DEFENSE LOGISTICS AGENCY
DEFENSE SUPPLY CENTER, COLUMBUS
POST OFFICE BOX 3990
COLUMBUS, OH 43218-3990

MEMORANDUM FOR MILITARY/INDUSTRY DISTRIBUTION

SUBJECT: Engineering Practices Study to improve the surge current testing of Tantalum capacitors.
Project number 5910-2010-025

EP study to update surge current test procedures in MIL-PRF-39003 and MIL-PRF-55365

FIGURE ??

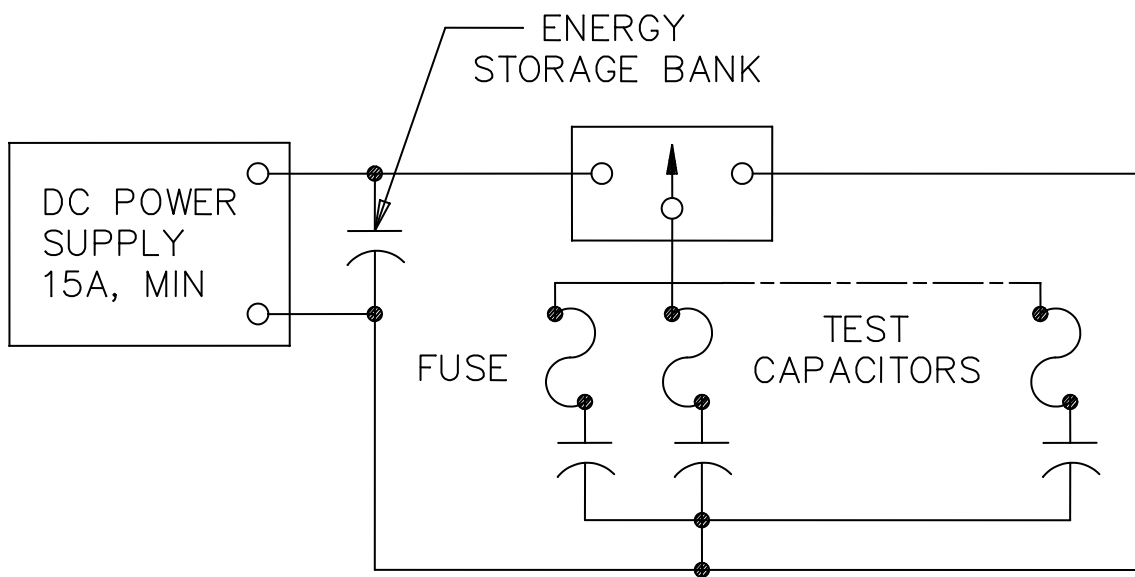
- h. surge current test setup (typical or equivalent). See figure ??

- b. Applied voltage: Rated voltage ± 2 percent from a power source having an energy storage bank of at least 50 times larger than the total capacitance value being tested. The capacitors shall be subjected to a minimum peak current $(I_{pk}) = V_r / (R_{dc} + ESR_{max})$, and the energy storage bank voltage drop of $\pm 2\%$ of rated voltage.

- c. Charge cycle: Each capacitor must reach target voltage in at most 10 times the capacitance value to be tested (e.g. 1ms for 100uF capacitor) and hold that voltage for 3 ± 2 seconds.

- d. Discharge cycle: 3 seconds ± 2 second to a voltage below 1 percent of rated voltage.

- e. The total dc resistance including the capacitor, wiring, fixturing, and output impedance of the regulated power supply to each test position during the charging cycle shall be a maximum of 1 ohm.

FIGURE ??

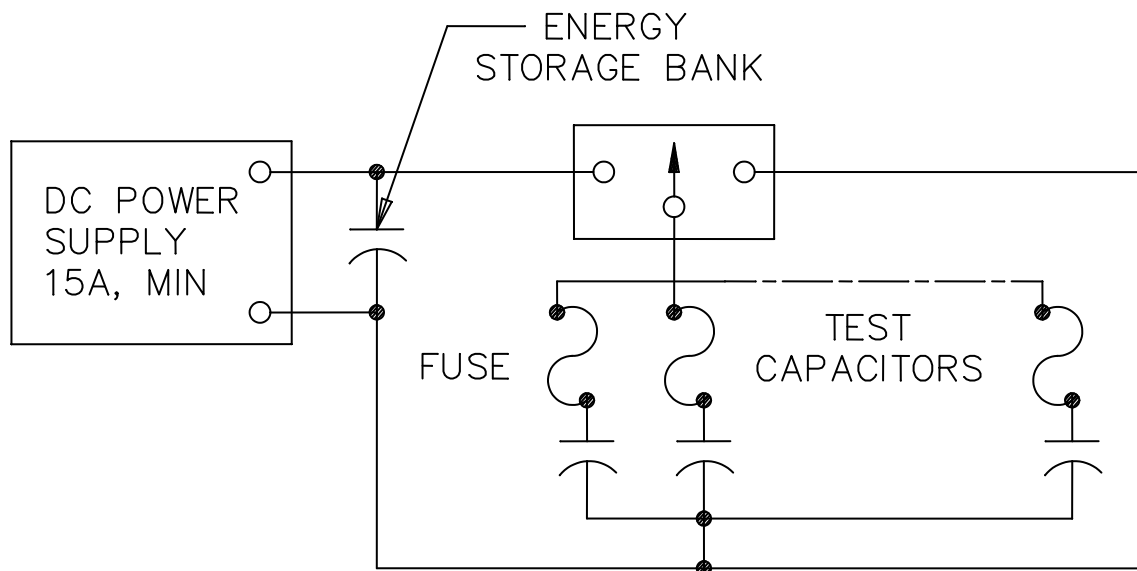
h. surge current test setup (typical or equivalent). See figure ??

- b. Applied voltage: Rated voltage ±2 percent from a power source having an energy storage bank of at least 50 times larger than the total capacitance value being tested. . The capacitors shall be subjected to a minimum peak current ($I_{pk} = V_r / (R_{dc} + ESR_{max})$), and the energy storage bank voltage drop of -2% of rated voltage.

- c. Charge cycle: Each capacitor must reach target voltage in at most 10 times the capacitance value to be tested (e.g. 1ms for 100µF capacitor) and hold that voltage for 3 ± 2 seconds.

- d. Discharge cycle: 3 seconds ±2 second to a voltage below 1 percent of rated voltage.

- e. The total dc resistance including the capacitor, wiring, fixturing, and output impedance of the regulated power supply to each test position during the charging cycle shall be a maximum of 1 ohm.
